USNRC APPLICATION
SUA-1341 License Amendment
Ludeman Project
Converse County, WY

TECHNICAL REPORT
REQUEST FOR ADDITIONAL INFORMATION
RESPONSE PACKAGE

June 2013

PROJECT NO.:	CADD:	CHECKED BY:	APPROVED BY:	PLOT DATE:	FIGURE
8201-2013-103	DDJ	AJE	RD	6/6/2013	FIG. 1
SITE FACILITY LAYOUT LUDEMAN ISR PROJECT URANIUM ONE JOHNSON COUNTY, WY

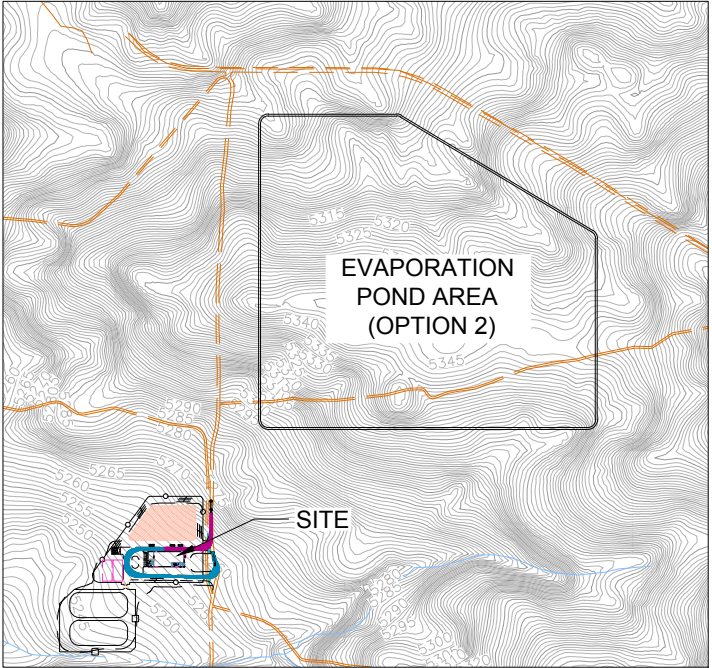
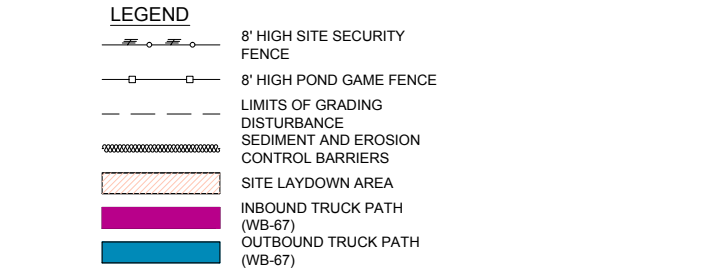
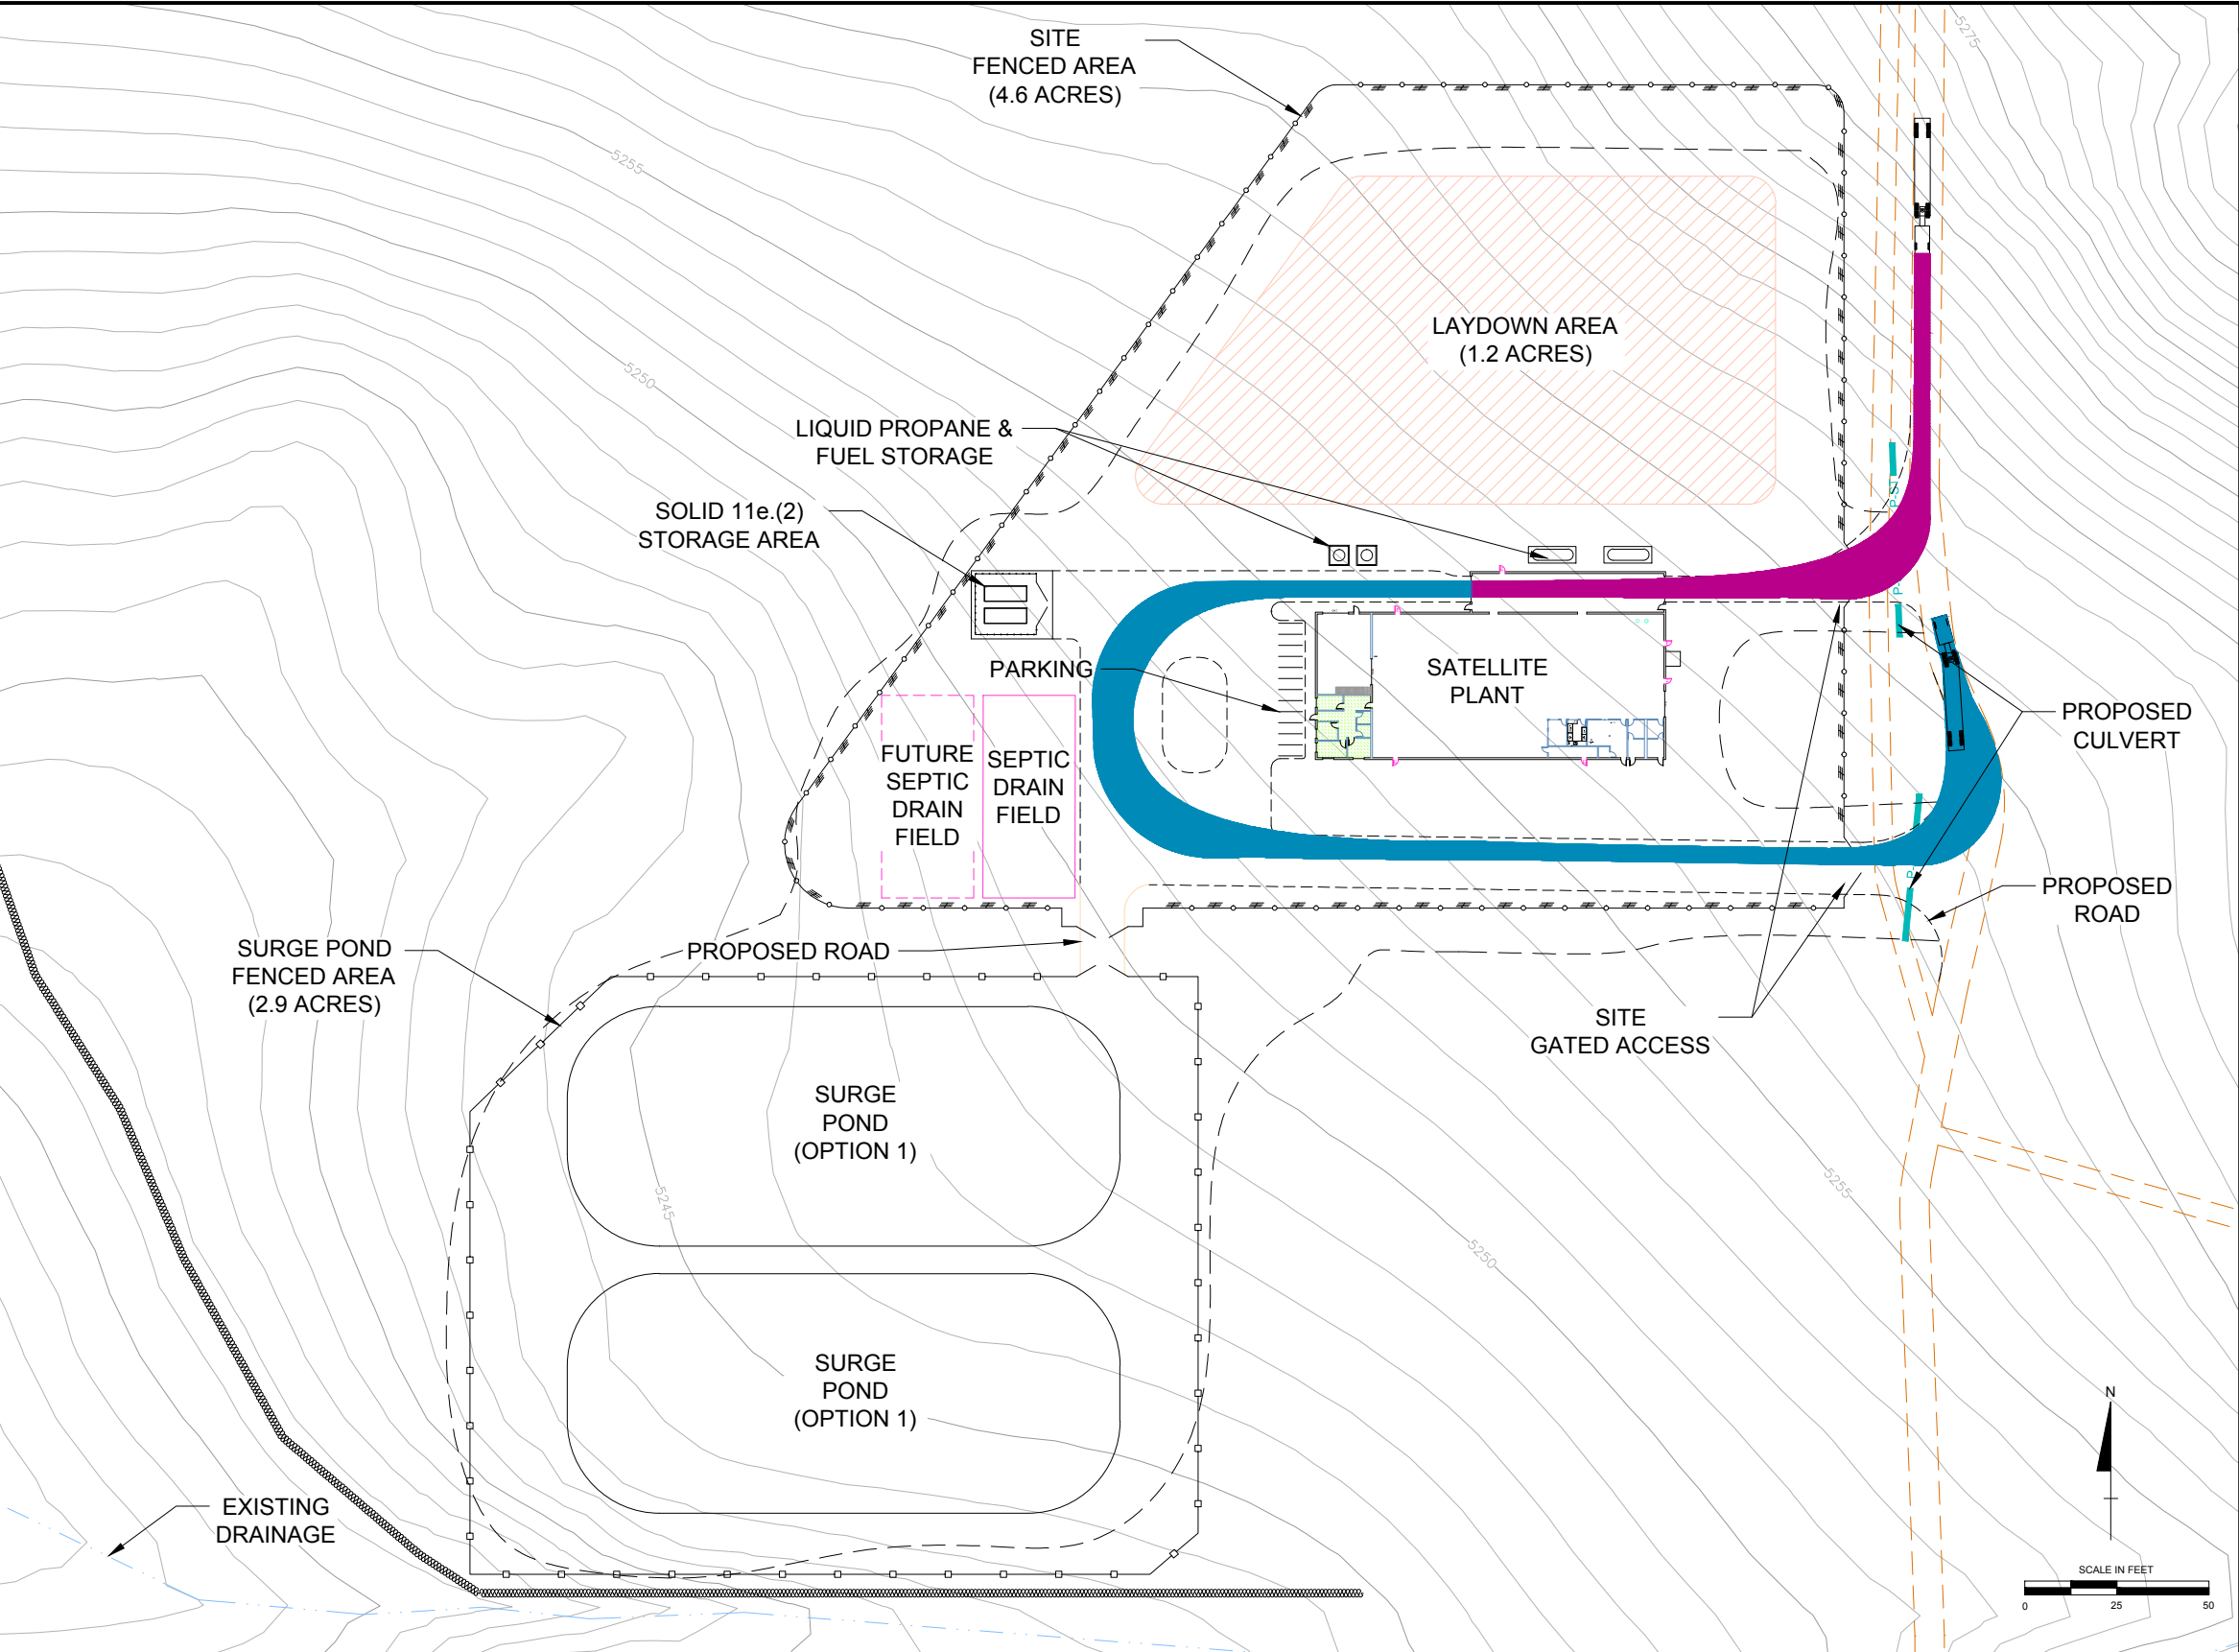
- A. Please provide additional design attributes and specifications for the structures that would be constructed at each of the Satellite areas.*
- B. Please provide information on the topographic setting where each facility and wellfield would be constructed at every Satellite area and how the design would accommodate the topography.*
- C. Please provide additional information on the final design specifications of the surface impoundments (i.e., ponds) that would be constructed at each Satellite facility, including the design for connectivity (i.e., pipelines) between the surface impoundments at the different Satellite areas and the deep-injection wells.*

Any additional available information regarding the facility design, both interior and exterior, at each Satellite area will assist the NRC during its assessment of the environmental impacts of the Proposed Action. Specifically, more detailed facility design than that shown on Figures 3-3 and 3-4 of the TR is needed for each Satellite. In addition, the number of surface impoundments at each Satellite must be clarified and the design of the impoundments finalized. Section 4.2.4.5 of the TR notes that the design presented in Addendum 4-A is preliminary and that an “inclusive surge pond design has not been completed.” In addition, Addendum 4-A of the TR notes that the second and third Satellite areas could require only one surface impoundment as the impoundments at the other Satellite areas could be used for redundancy. Final information on the overall design of Satellite areas will support the NRC’s environmental impact analysis.

Updated facility design information is provided in the revised TR Sections 3 and 4. The revised sections and associated figures provide information on current designs and geotechnical investigation for facilities within the satellite area. The proposed satellite plant layout and site facility layout is provided below.

An evaporation pond design plan will be added as an Addendum 4-B once design is completed. The pond design plan will include:

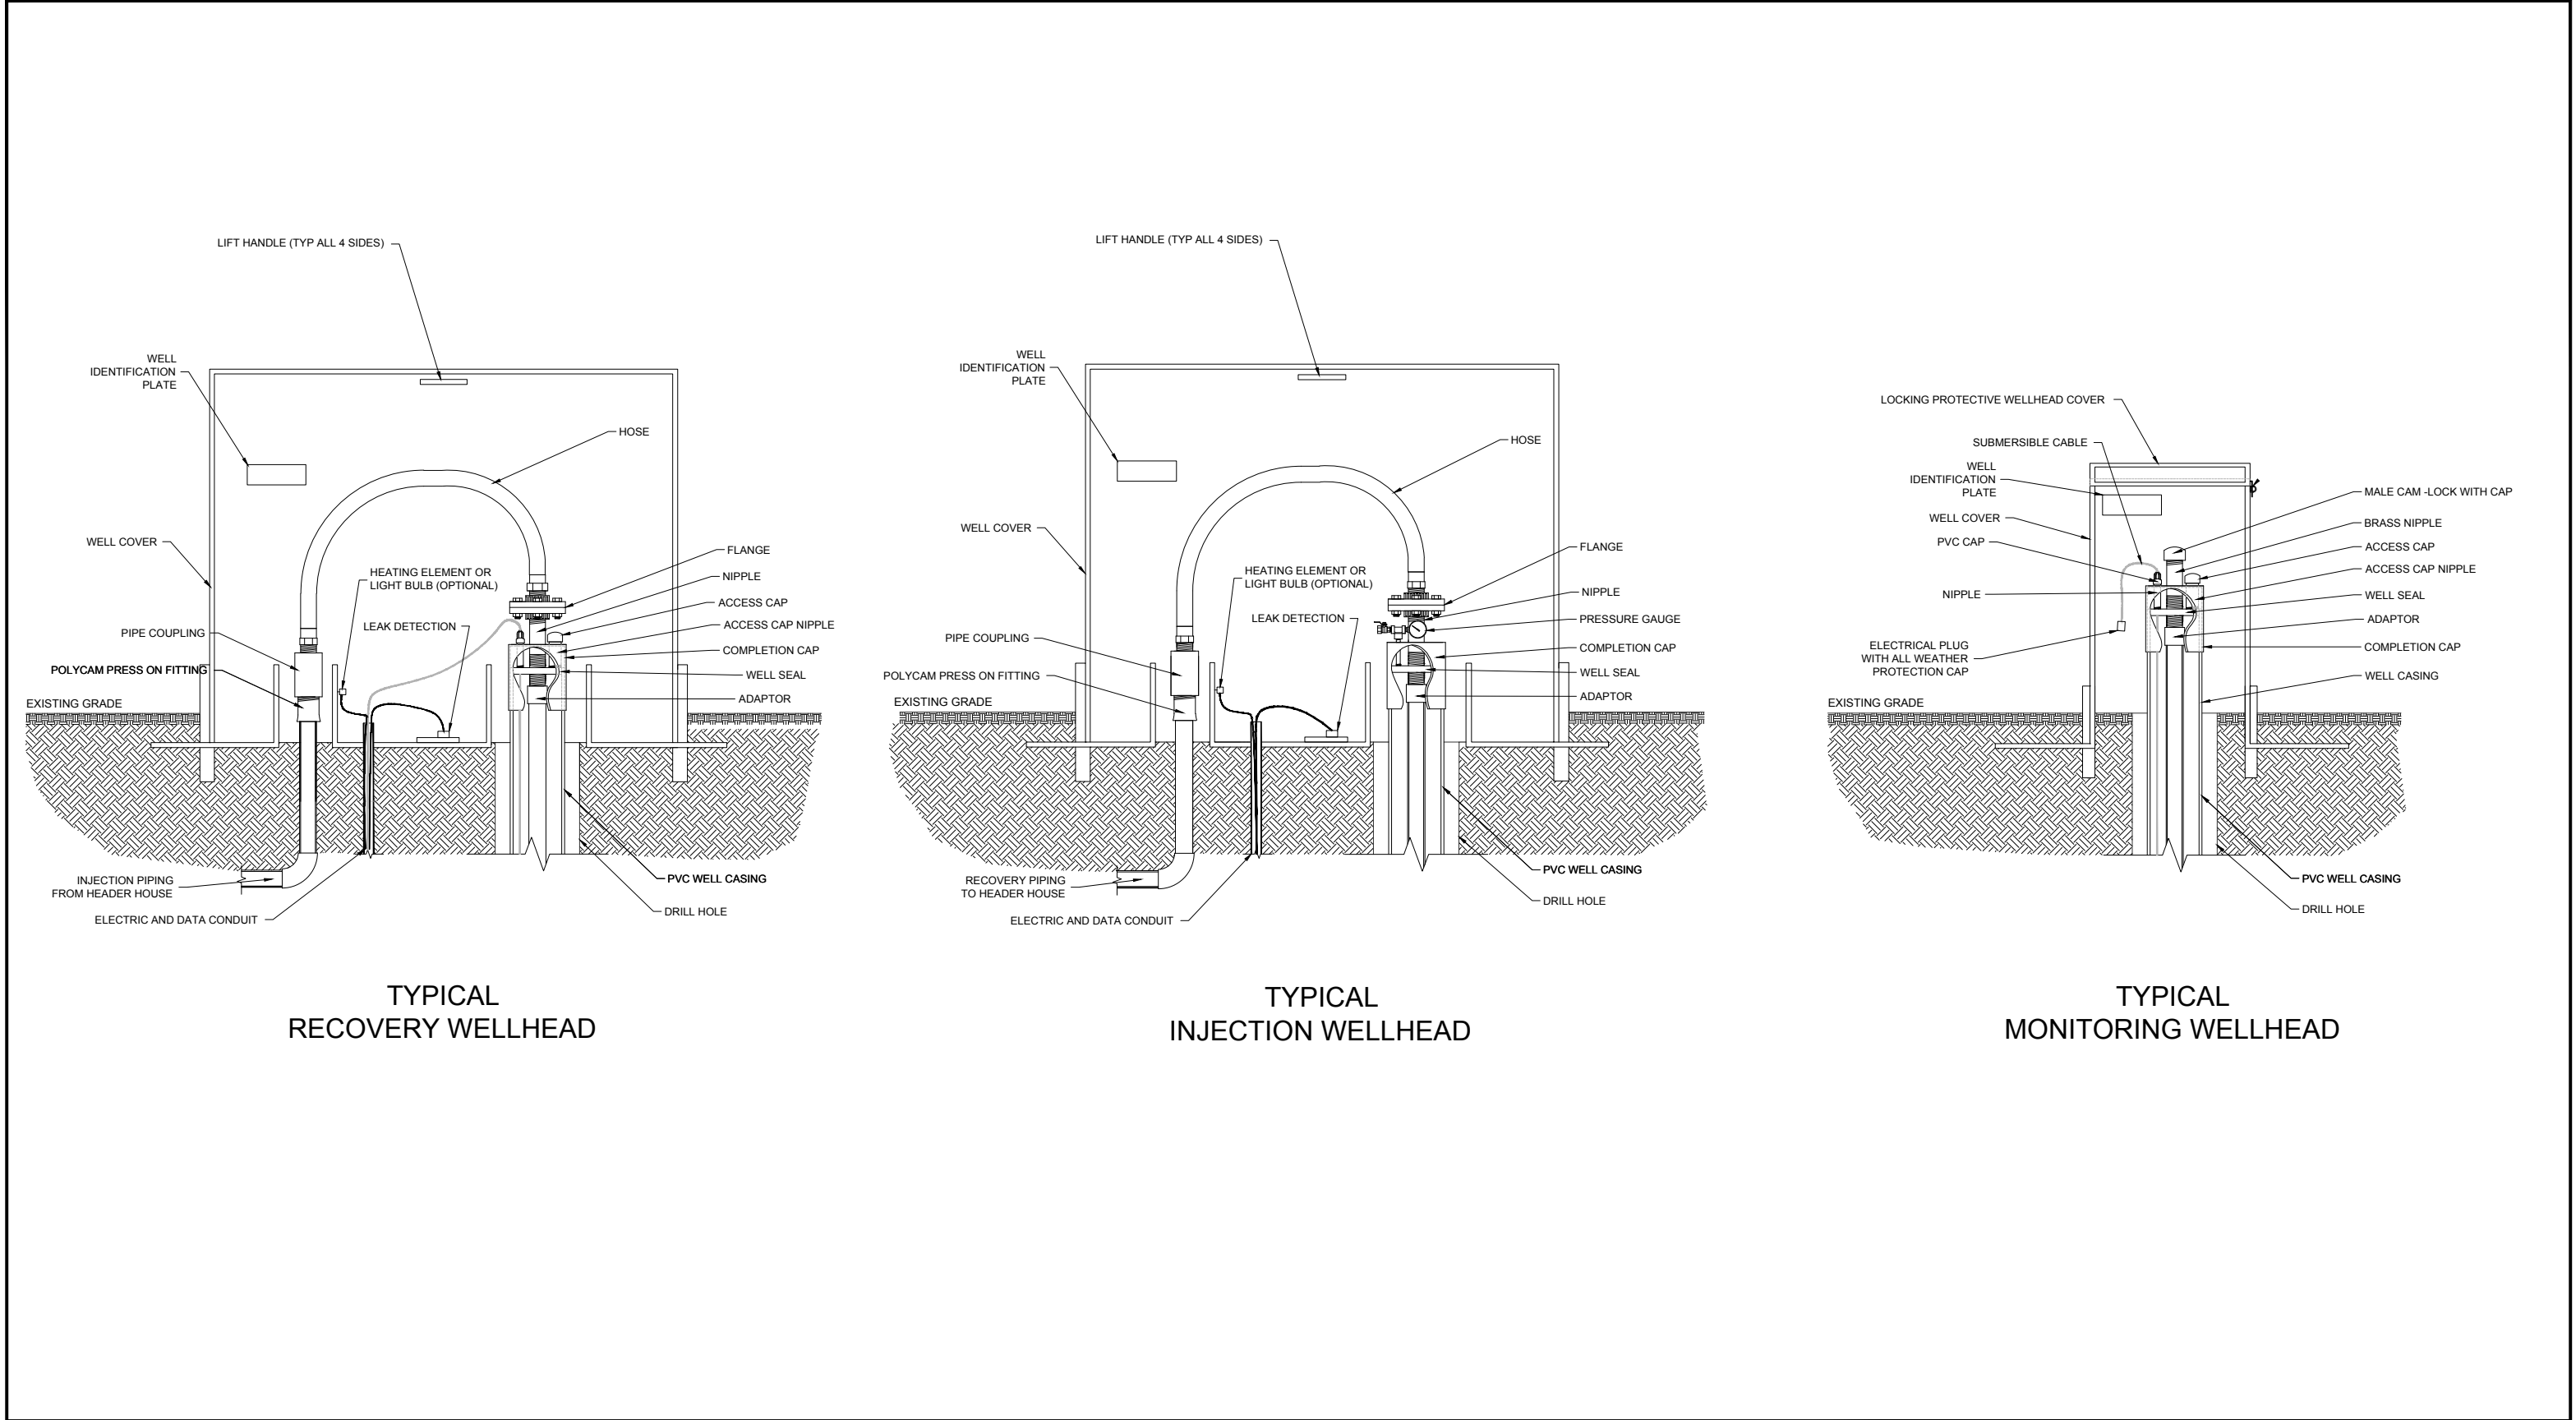
Please provide the design details of a typical header house and wellhead enclosure at a Satellite wellfield.

Uranium One has addressed the header house design in response to TR RAI-54. Design details including a diagram of a typical header house may be found in the TR RAI-54 response.

Uranium One is providing a schematic of the typical wellhead enclosures showing design features to support the NRC’s impact analysis. At this time Uranium One does not propose to vent the wellhead structures and TR Section 4.1.2.1 will be revised accordingly. The following figure provides wellhead design information and has been added to TR Section 3:
